1 ADDENDUM #5

PROJECT TITLE
**Queens County Depot
Phase 5b**

SHEET TITLE
**Boring Details
Addenda #5**

REVISIONS:	DATE:	Feb. 1, 2019
	DRAWN BY:	SPM, E.I.T.
	PROJECT NUMBER:	171048
	DRAWING NUMBER:	SK-02

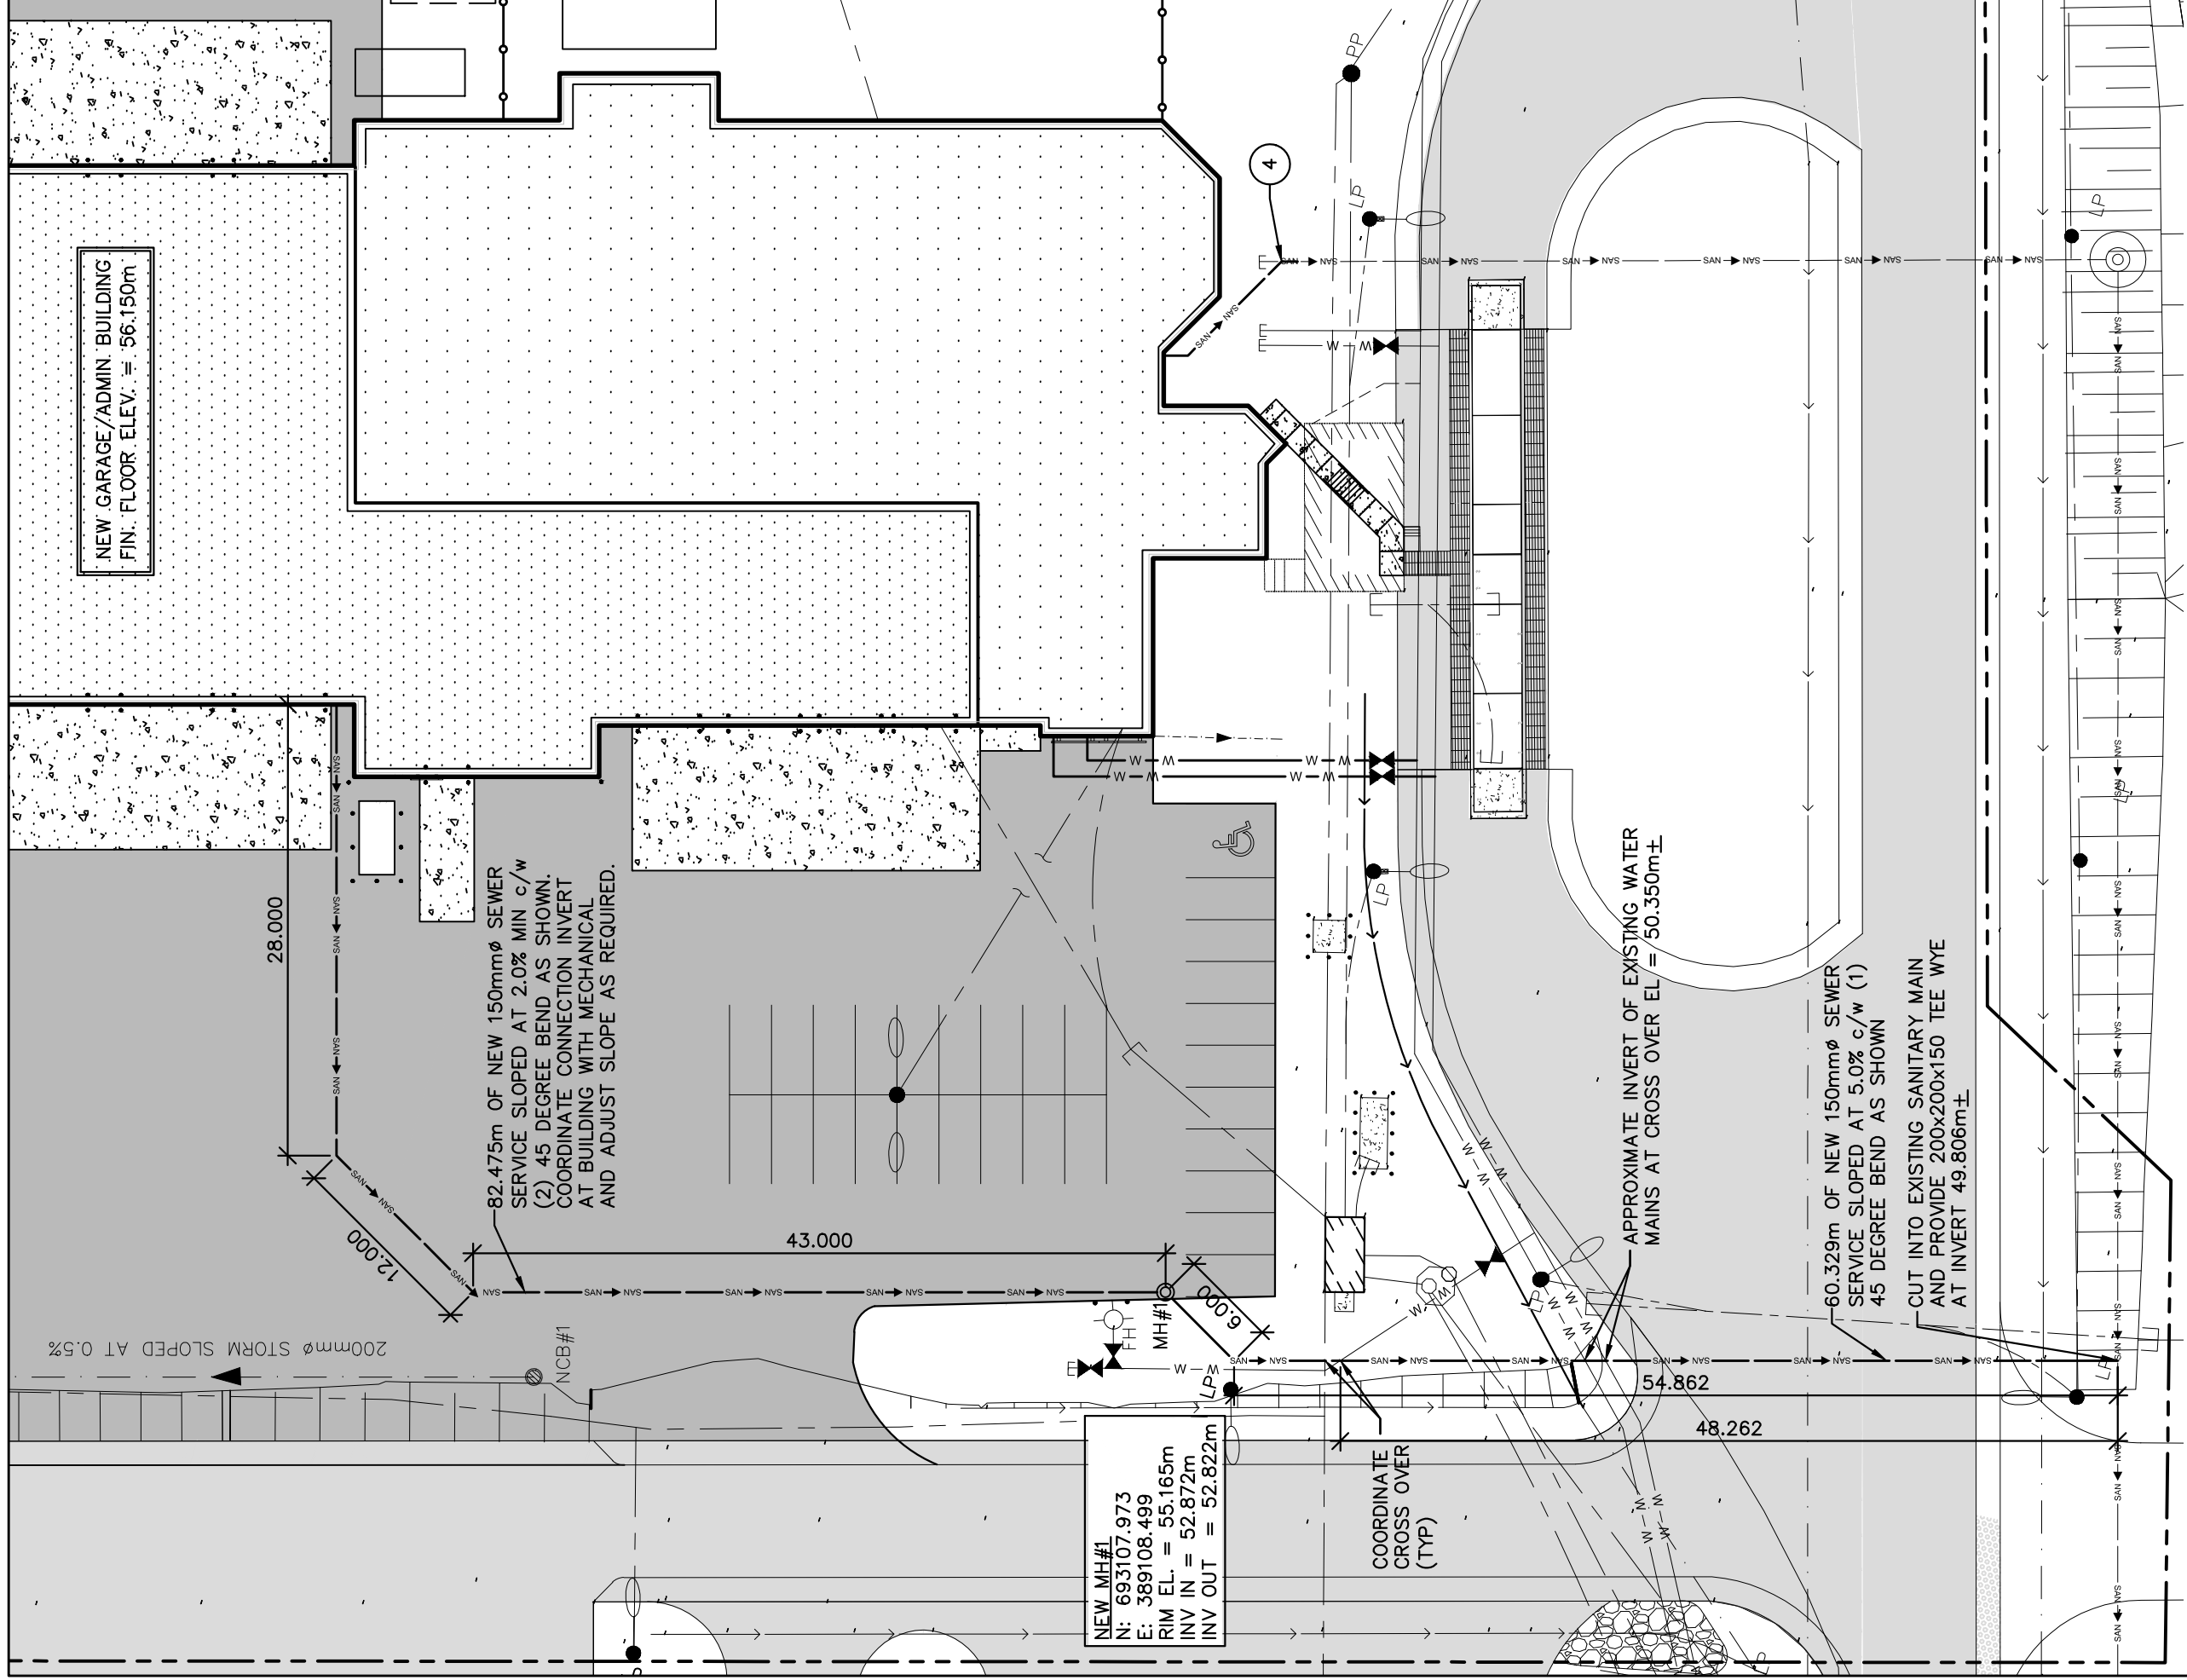
- .1 Reference Drawing C101 - Site Plan:
 - .1 To limit disruption to site operation during construction, trenching through existing asphalt driveway is unacceptable and Contractor shall drill and bore under asphalt driveway to install new sewer services, as per SK-02 - Boring Details, attached to and forming part of this addendum.

SANITARY SERVICE PLAN
 SCALE: 1:400

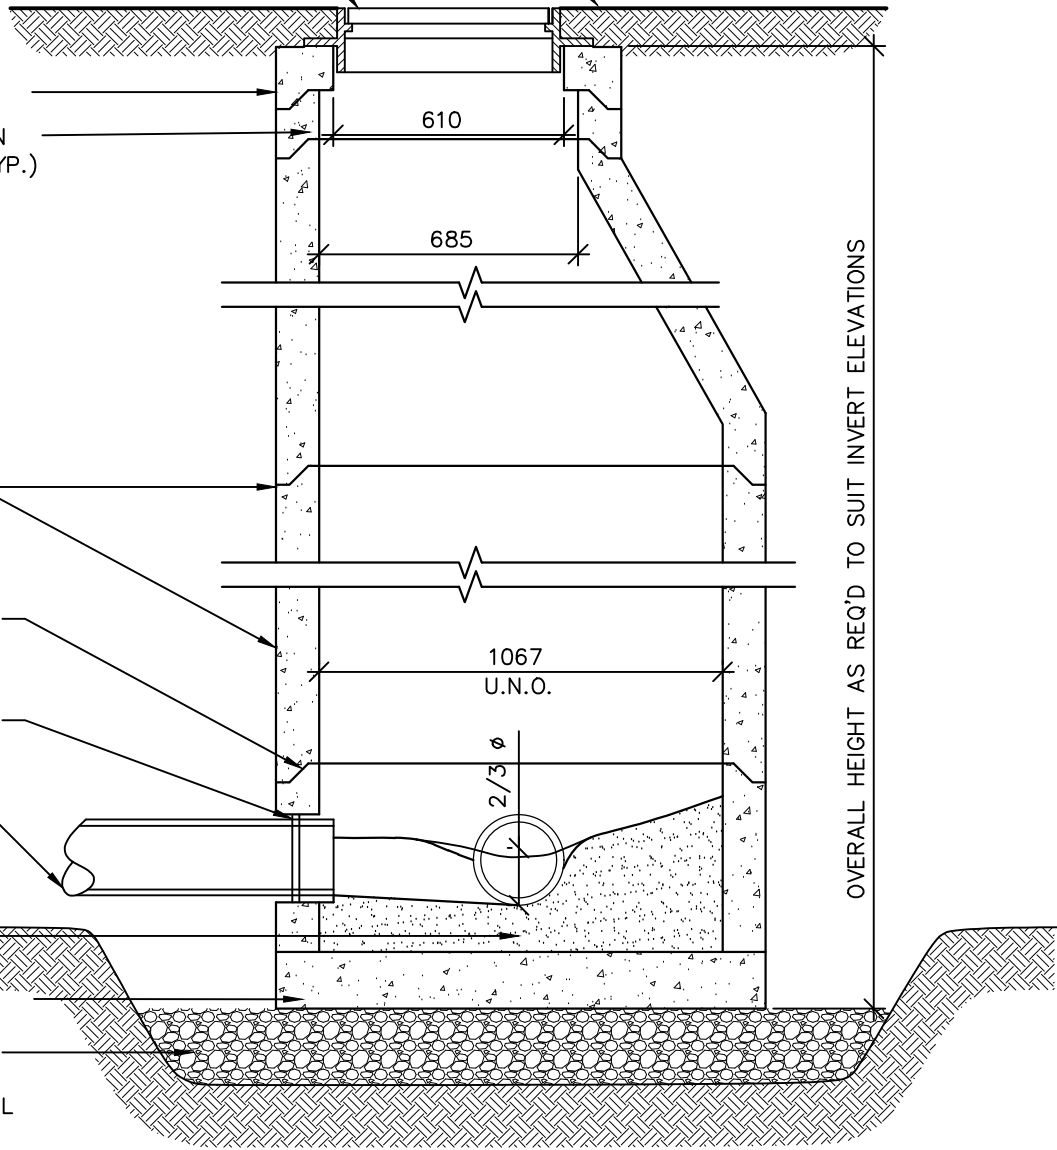
- .2 Delete the following Note stating "143.3m of new 100mm sewer service sloped at 1.5% min c/w (4) 45 degree bends as shown." and replace with scope indicated on sketch SK-07 - Sanitary Service Plan and SK-08 - Sanitary Manhole, attached to and forming part of this addendum. These new sketches indicate the two separate runs of sanitary service with a new sanitary manhole.

PA RISER
SK-09 NTS

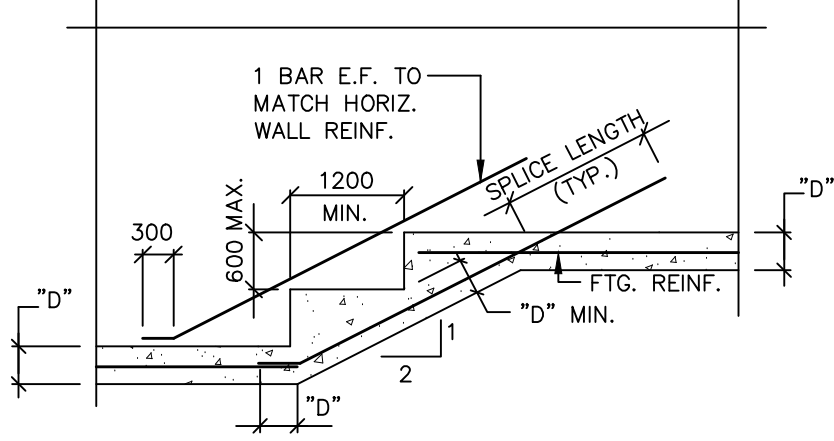
- .39 Reference Drawing E501 - North Floor Plan - Systems:
- .1 Reference Detail 1/E501:
 - .1 Refer to SK-09 for additional information on paging riser, sketch is attached to and forming part of this addendum.

- .2 Refer to SK-09 for additional information on paging riser, sketch is attached to and forming part of this addendum.
- .41 Reference Drawing E602 - Power Schematics, Elevation & Schedules:
